SAFETY RECALL – OUTER ROLLSTOP BARRIER LATCH  
ON BRAUN CENTURY AND VISTA 2ND GENERATION PARALLEL ARM LIFTS

## Service Bulletin 37679

# Outer Barrier Latch, Bracket, and Clevis Pin Retrofit 37679

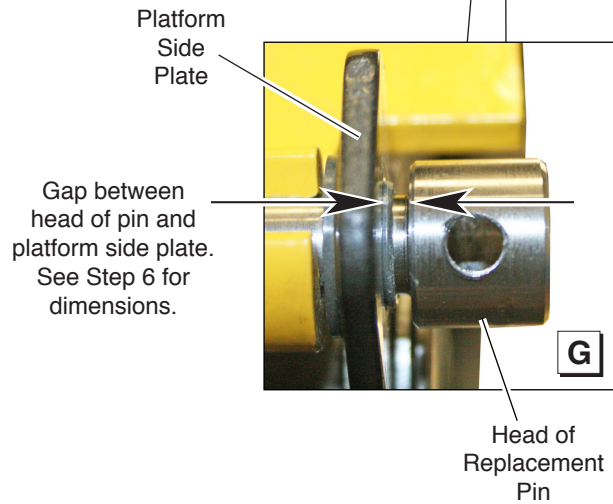
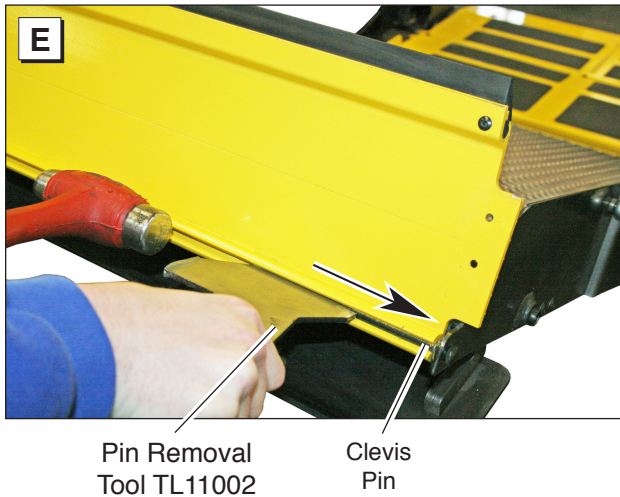
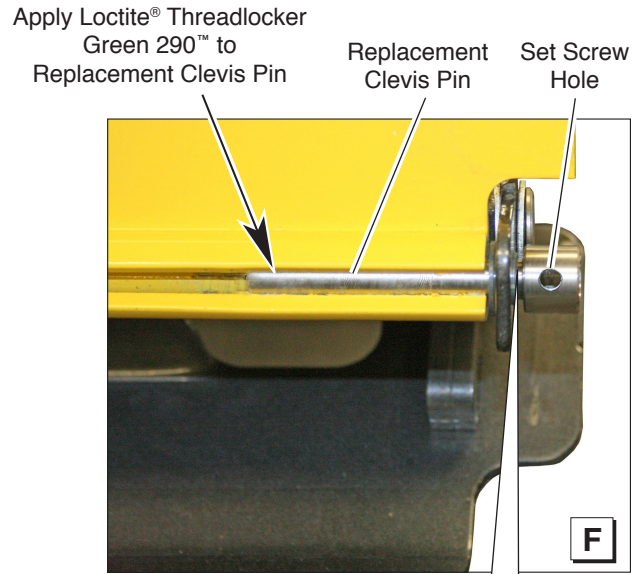
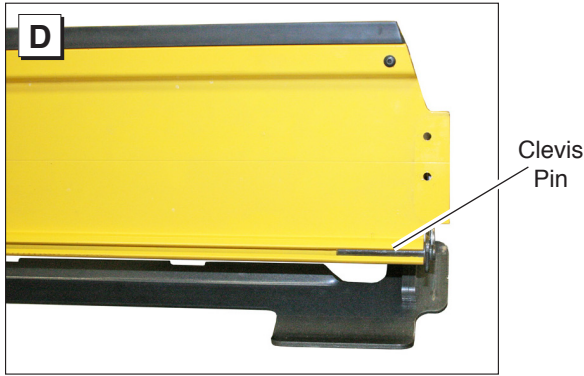
5. Remove clevis pin from platform/outer barrier using pin removal tool TL11002. The clevis pin is a friction fit and removal may be difficult. See Photos D and E.

6. Install replacement pin. Temporarily install roll stop pin cap on roll stop pin to avoid damaging the head of the replacement pin during installation. Remove cap. Refer to Photo J. Ensure that a gap exists between the head of the replacement pin and the platform side plate (See Photo G):

- Century: 1/16" gap both sides
- Vista: 1/8" gap on microswitch side, 1/16" opposite side.

During installation, position set screw hole facing outward for easy access. Apply Loctite® Threadlocker Green 290™ or equivalent on clevis pin after installation. See Photos F and G.

**Figure 1**

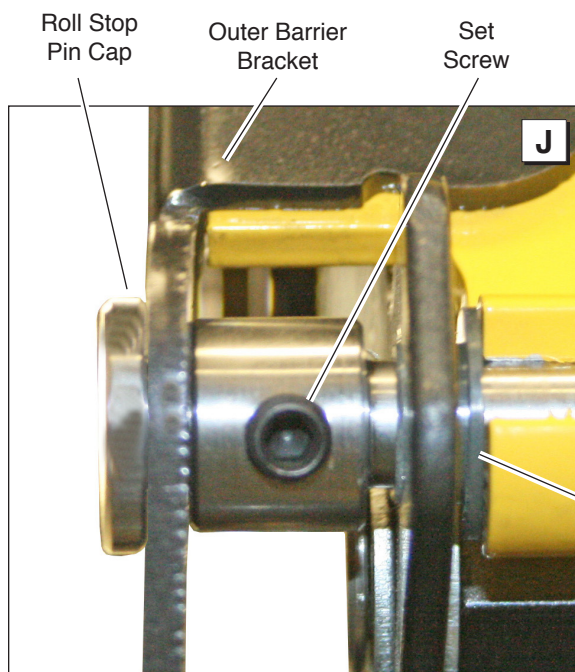
8. Install replacement outer barrier bracket/latch assembly using hex socket and washer removed in step 4. Apply Loctite® Threadlocker Blue 242™ or equivalent on threads. Refer to Photo A and Figure 1.

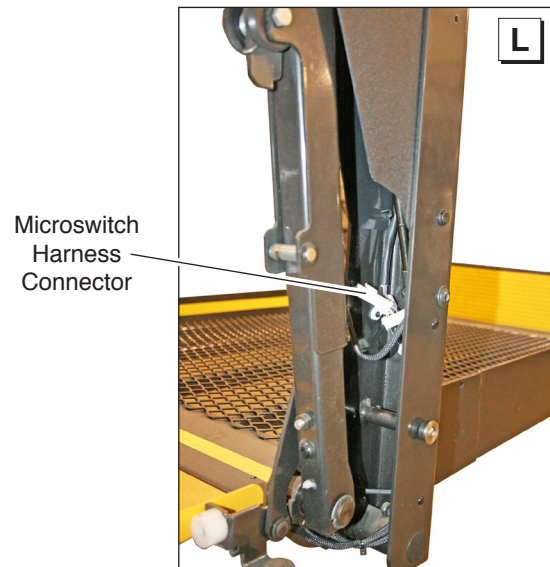
14. Install replacement outer barrier latch/bracket assembly using hex socket and washer removed in step 4. See Figure 2.
